Access Compliance Report

Public Rights-of-Way

Intersection ID: 51342	Main Street: MCMULLEN_WY	Cross Street: MONROE_RD	Location: SW
ADA ID: 52C80C334AEA	Ramp Type: PerpDiag	Initial Pass/Fail: Fail	Overall Compliance: No
Severity Score: 22.5			
Codes/Mitigation Info/Possible Solution		Field Measurements/Component Compliance

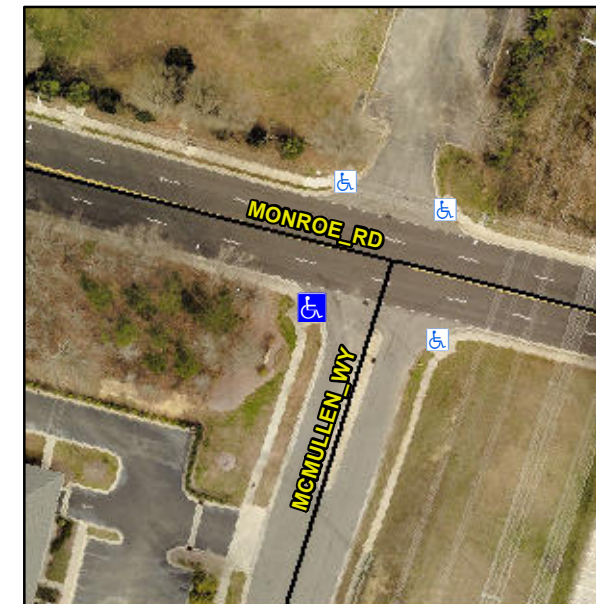
Not Found, R304.5.1, R304.2.2, R304.5.3

Compliance	Description	Data	Compliance	Description	Data
N/A	Ramp Length (in)	96.0	No	Ramp Slope (%)	8.5
No	Ramp Width (in)	47.0	No	Ramp XSlope (%)	3.6
N/A	Flare Type LT	N/A	N/A	Flare Type RT	N/A
N/A	Flare Slope LT (%)	N/A	N/A	Flare Slope RT (%)	N/A
N/A	Flare Traversable LT?	N/A	N/A	Flare Traversable RT?	N/A
N/A	Landing Length (in)	N/A	N/A	DWS Provided?	N/A
N/A	Landing Width (in)	N/A	N/A	DWS Contrast?	N/A
N/A	Landing Slope (%)	N/A	N/A	DWS Length (in)	N/A
N/A	Landing X Slope (%)	N/A	N/A	DWS Full Width?	N/A
N/A	Landing Curb? (Y/N)	N/A	N/A	DWS Offset (in)	N/A
N/A	Shared Landing?	N/A			
N/A	Gutter Ponding?	N/A	N/A	Gutter Slope (%)	N/A
N/A	Gutter Lip Ht (in)	N/A	N/A	Gutter X Slope (%)	N/A
N/A	Painted X Walk1?	No	N/A	Painted X Walk2?	No
	X Walk 1 Direction	To SE		X Walk 2 Direction	To NE
N/A	X Walk 1 Width (in)	N/A	N/A	X Walk 2 Width (in)	N/A
	X Walk 1 Slope (%)	3.1		X Walk 2 Slope (%)	2.5
	X Walk 1 X Slope (%)	0.7		X Walk 2 X Slope (%)	4.7

Remove & Replace Curb Ramp With Two New Directional Ramps or Equivalent.
